CITY OF CODY
PLANNING, ZONING AND ADJUSTMENT BOARD
TUESDAY, MAY 8, 2012
CITY HALL COUNCIL CHAMBERS @ 12:00 NOON

**CITY OF CODY
PLANNING, ZONING AND ADJUSTMENT BOARD
STAFF REPORT**

MEETING DATE:	MAY 8, 2012	TYPE OF ACTION NEEDED	
AGENDA ITEM:		P&Z BOARD APPROVAL:	X
SUBJECT:	CODY LEGACY INN, PROPOSED PERGOLA & COVER SPR 2012-17	RECOMMENDATION TO COUNCIL:	
PREPARED BY:	TODD STOWELL, CITY PLANNER	DISCUSSION ONLY:

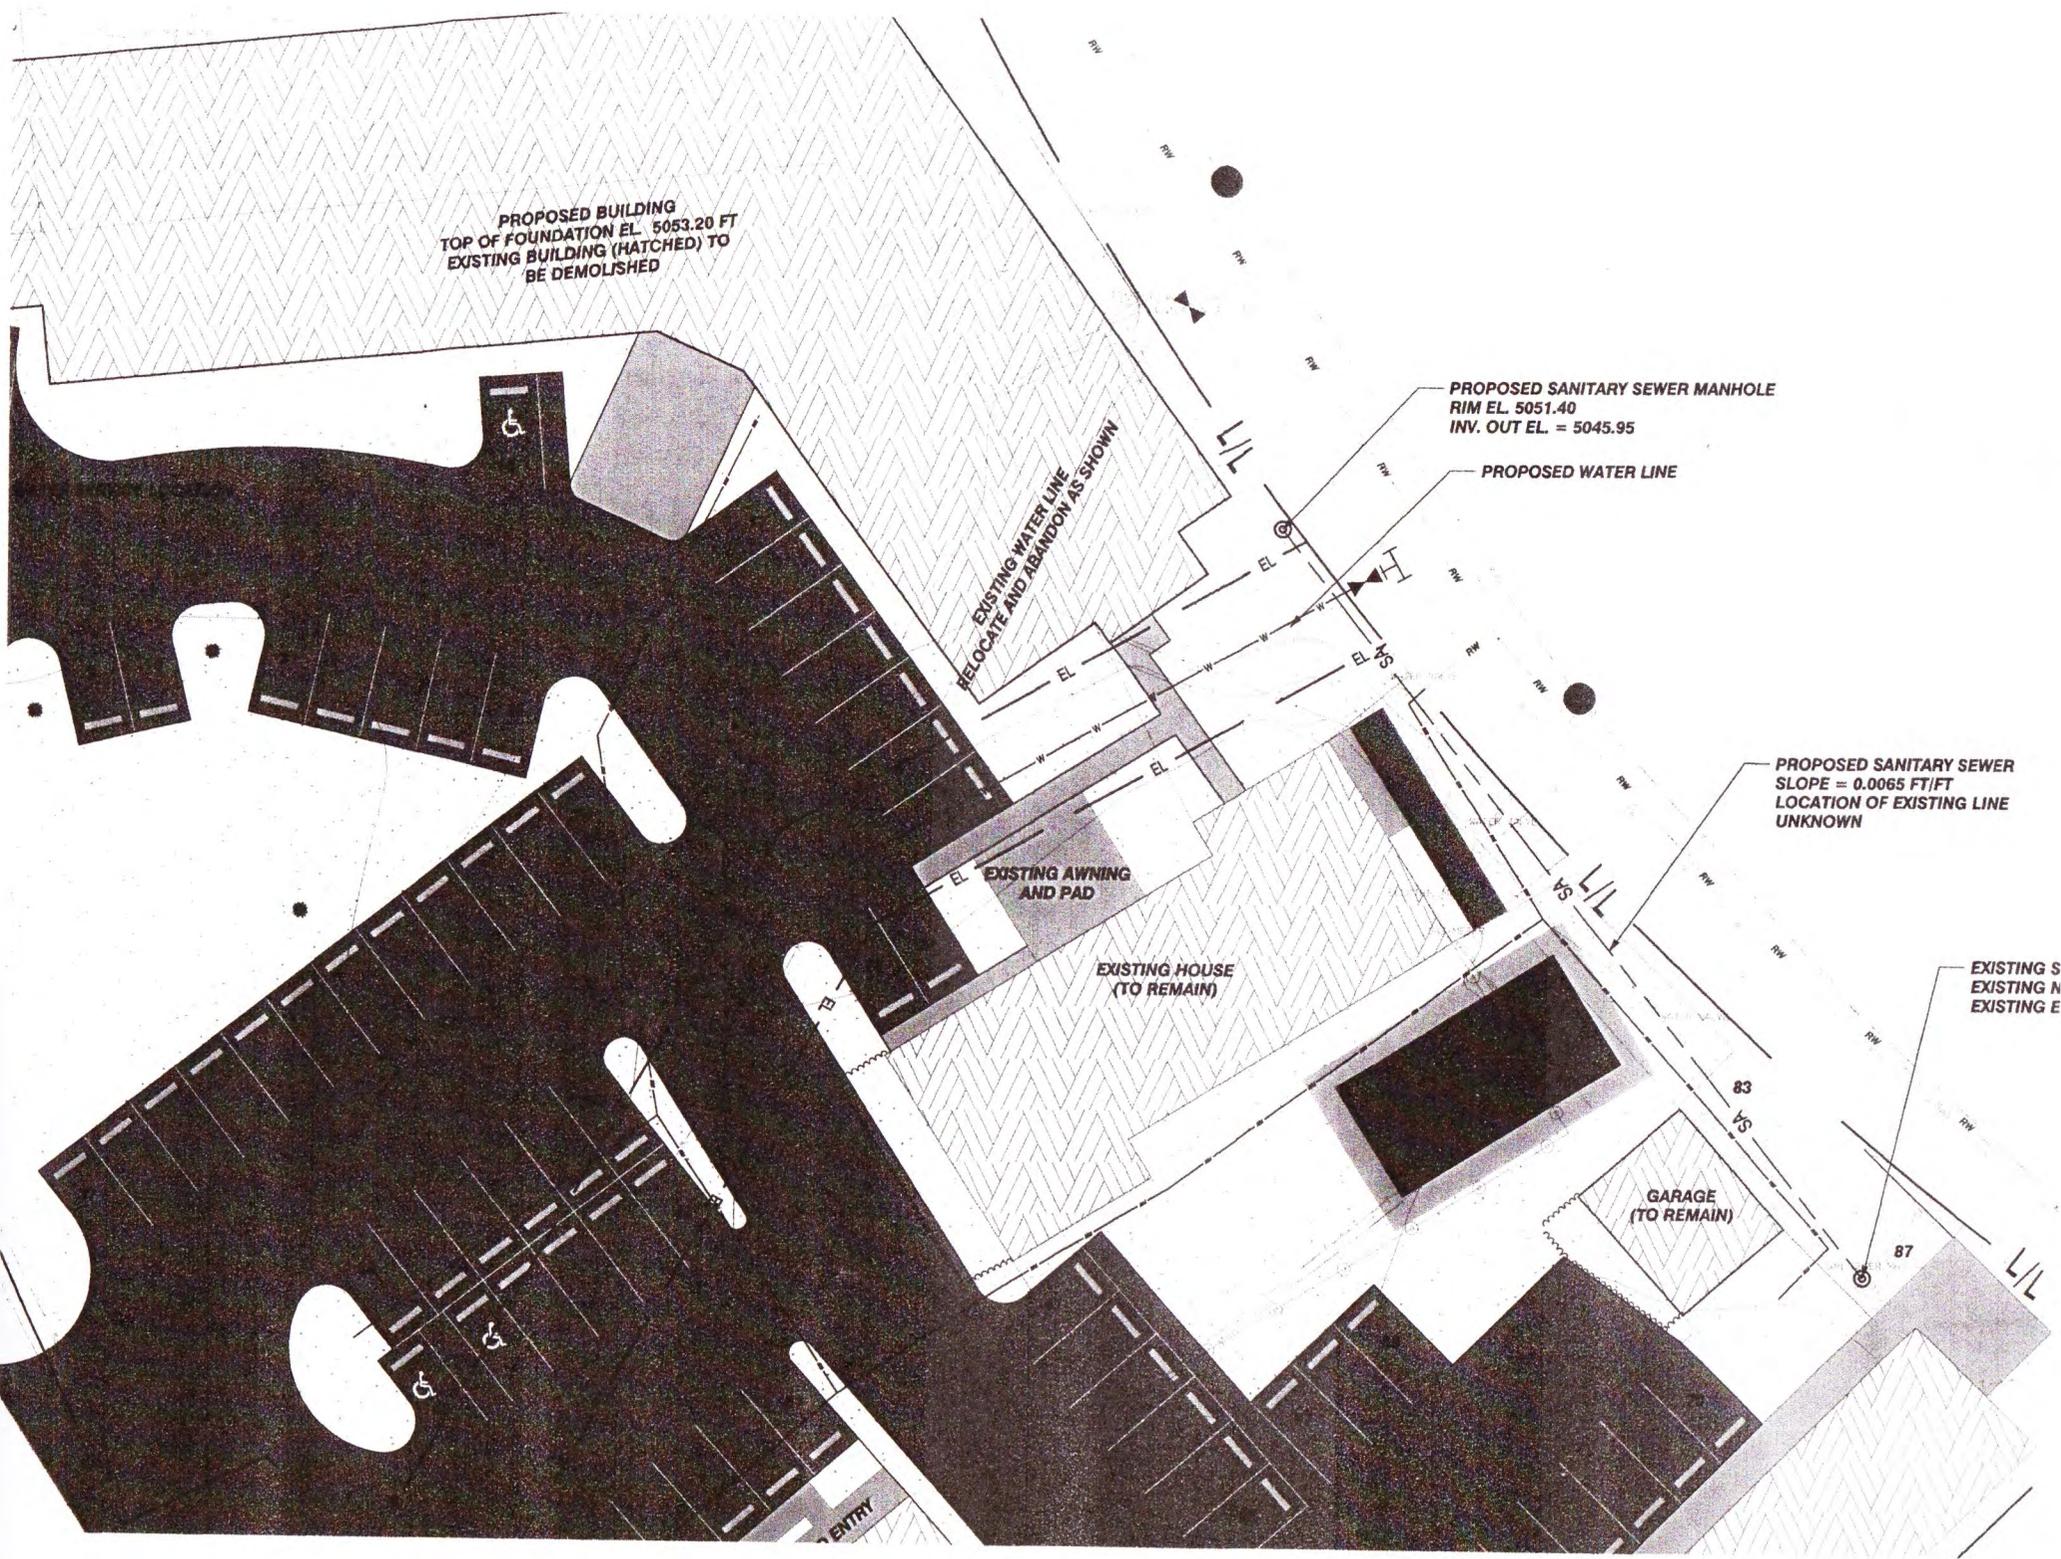
Care will need to be taken so that the foundation posts for the pergola are spaced and located such that they do not conflict with the private on-site raw water line, shown as **a dashed line between the pool and "existing house" on the site plan.**

Five parking spaces will be "lost", reducing the total number from 76 to 71. The parking ordinance requires one space per room (54) plus one per employee (max. 13 at peak season), for a total of 67 spaces.

The vehicle travel lane between the pergola and building to the west will be approximately 25-feet wide, which meets fire lane and parking lot aisle requirements.

Staff would also want it to be understood that the pergola has not been reviewed for compliance with the pool enclosure standards of the building code, as more detail is necessary for that review.

Approve the pergola and shed roof/carport as proposed. Minor changes to comply with the building code pool enclosure requirements are authorized if needed.

PRELIMINARY PLAT

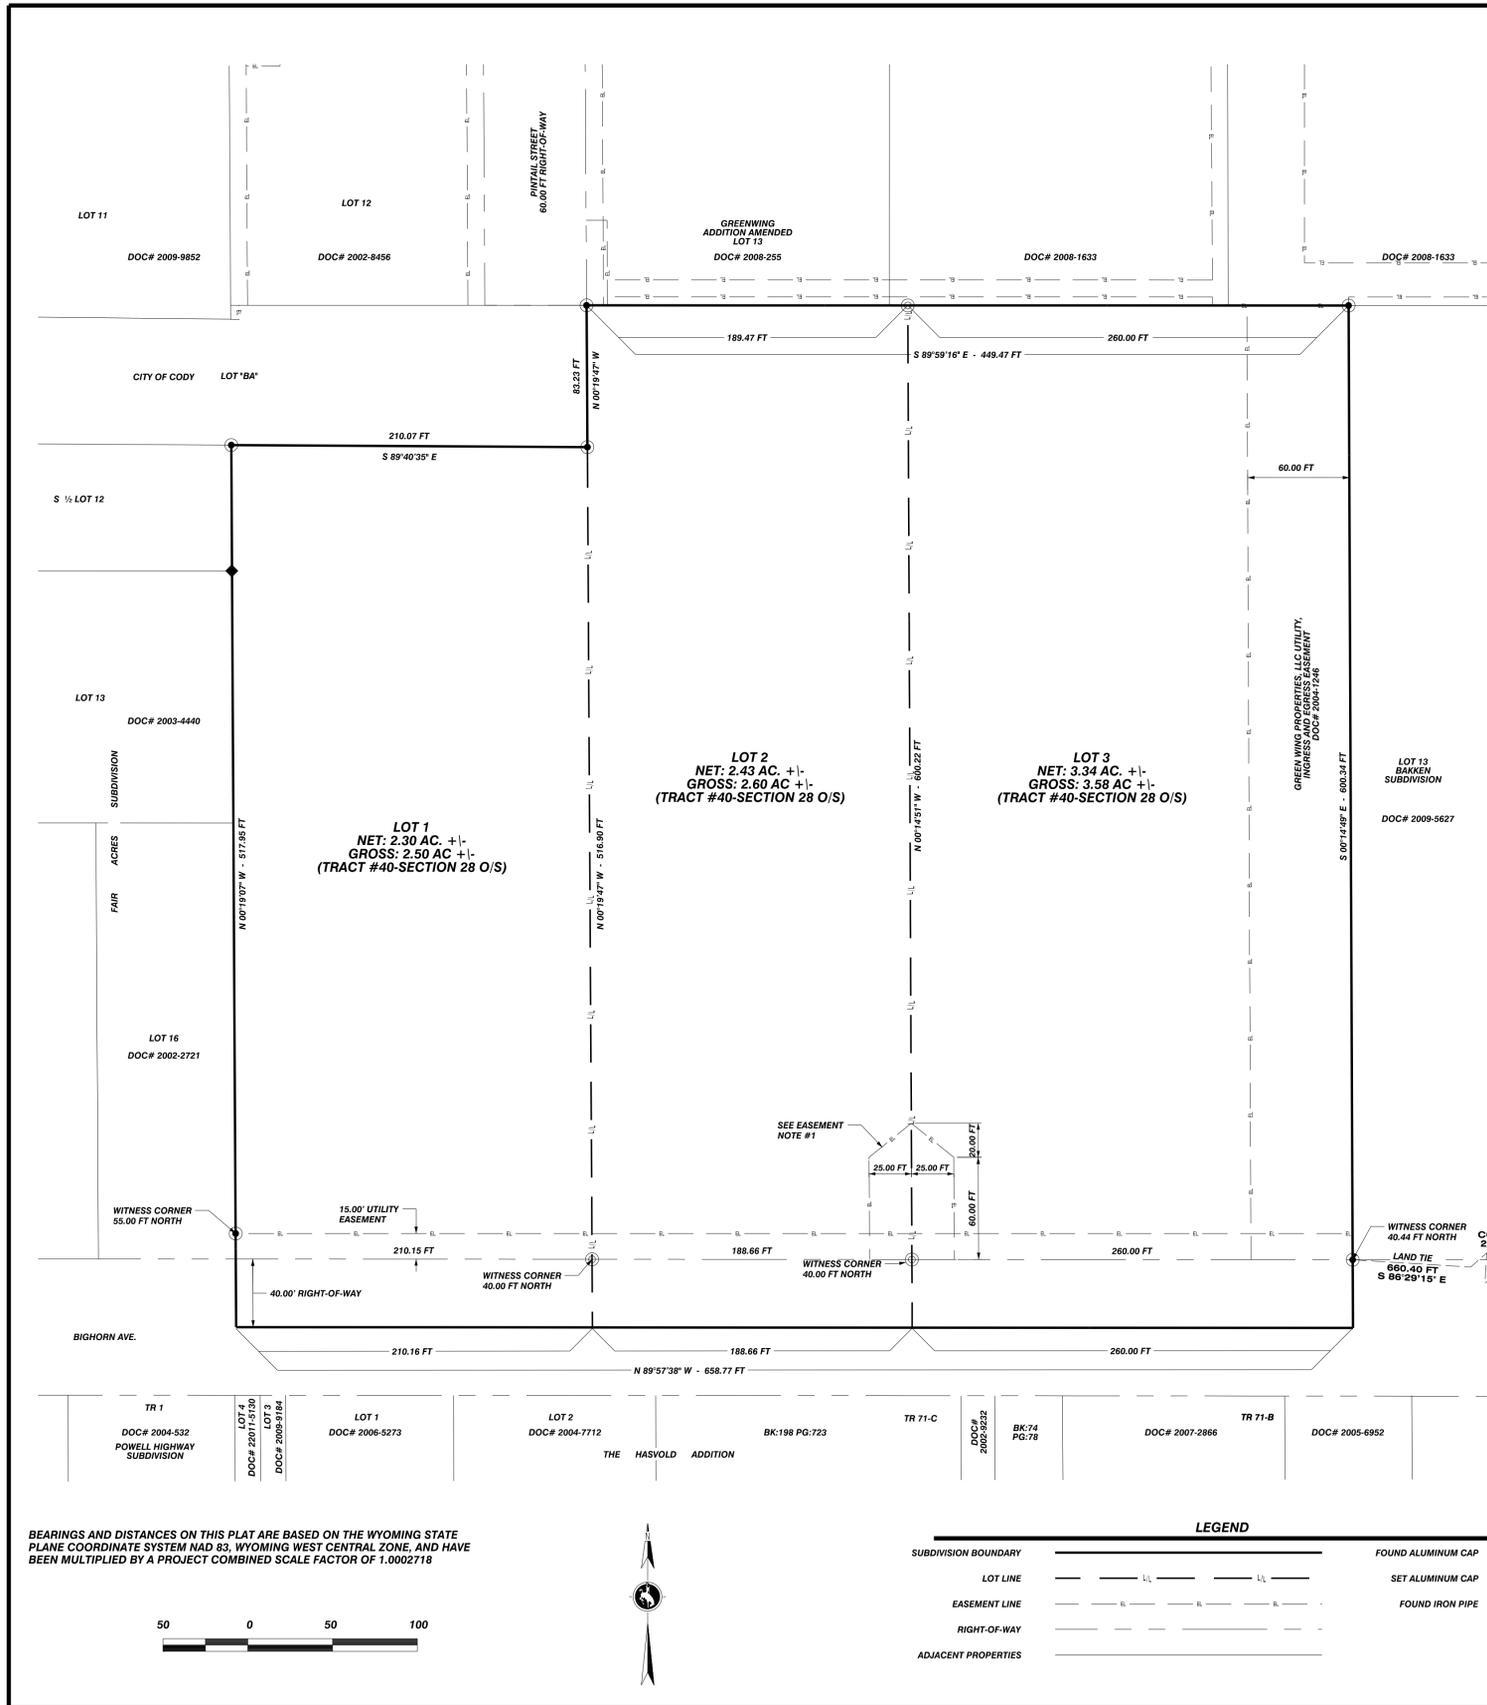
4. Access to each lot is provided from Bighorn Avenue, a State access-controlled highway. Approved approach permits must be provided for the proposed access points prior to final plat approval by Council. Construction of the new approach and removal of the unused approach must be completed or bonded for prior to final plat approval by Council. Access to Bighorn Avenue is limited to the approach locations permitted by WYDOT, as is noted on the final plat.

5. **The 50' wide common access easement at the WYDOT approach is adequate for platting purposes of Lots 2 and 3.**
6. The 60-foot wide ingress and egress easement on the east side of the property was established previously. However, it is not required by this minor subdivision. Improvement of this easement is not required for this plat.

7. A storm water system is not available in the immediate area. A note is on the final plat that storm water will be retained on-site in accordance with the City storm water policy.

1. Receipt of all outstanding letters from the utility companies, and compliance with any conditions thereof prior to Council action.

2. Installation of, or performance bond for, the **4"** sewer stubs into each lot.
3. **Payment of ¾" or larger water taps for each lot.**
4. Submit approach permits from WYDOT for access to all lots.
5. Construction of the new shared approach to WYDOT standards, and replacement of the unused approach with standard curb and gutter meeting WYDOT standards, or submittal of a performance bond for such work.
6. Include the notes already on the Final Plat, including storm water control and limited access.
7. Provide a recordable original of the Final Plat, meeting all applicable requirements, for signature and recording. Recording fees shall be the responsibility of the applicant.
